STANDARD DEPARTURE CHART - INSTRUMENT

RJST / MATSUSHIMA

SID and TRANSITION

TACAN Y RWY25

SOUTH FIVE DEPARTURE

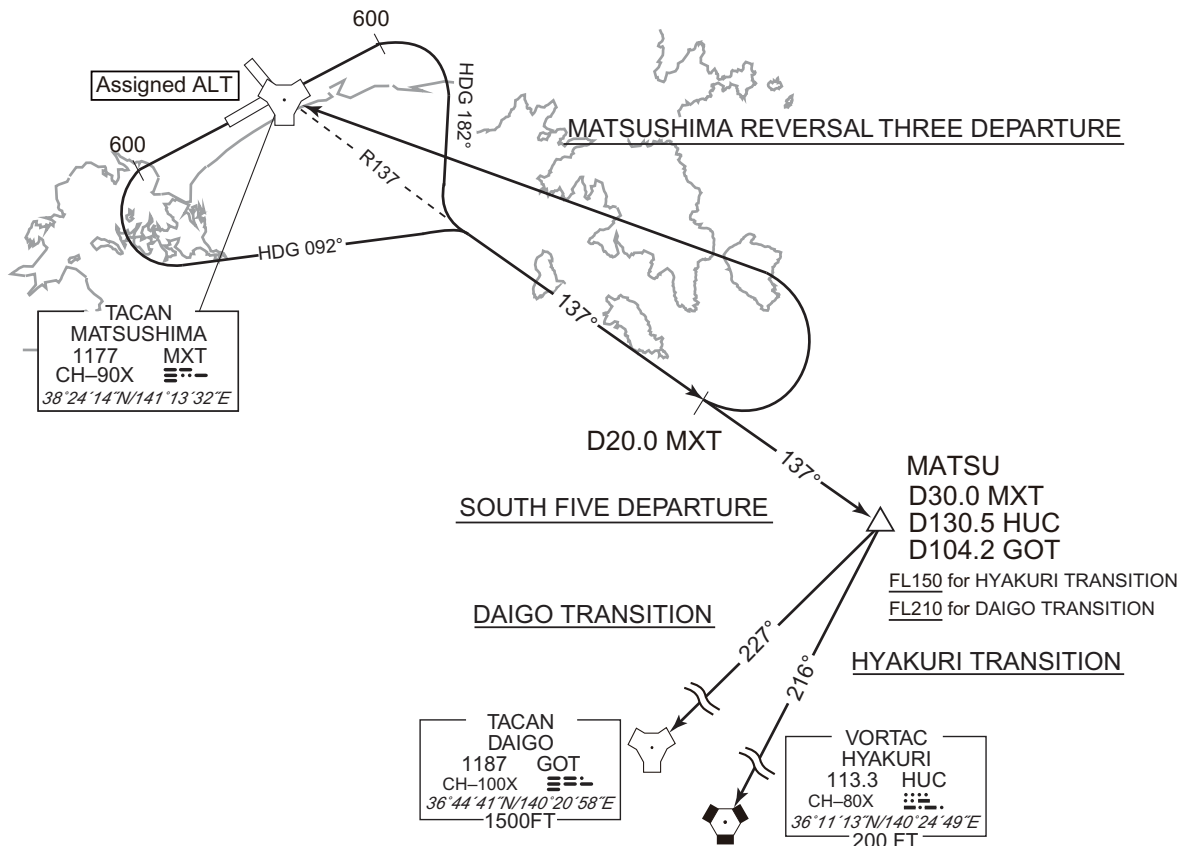
CHANGE : PROC renamed(MATSUSHIMA REVERSAL THREE DEPARTURE, SOUTH FIVE DEPARTURE). PROC course(MATSUSHIMA REVERSAL THREE DEPARTURE, SOUTH FIVE DEPARTURE). ALT restriction for RWY07. Note added(HYAKURI TRANSITION). Note(MATSUSHIMA REVERSAL THREE DEPARTURE, SOUTH FIVE DEPARTURE).
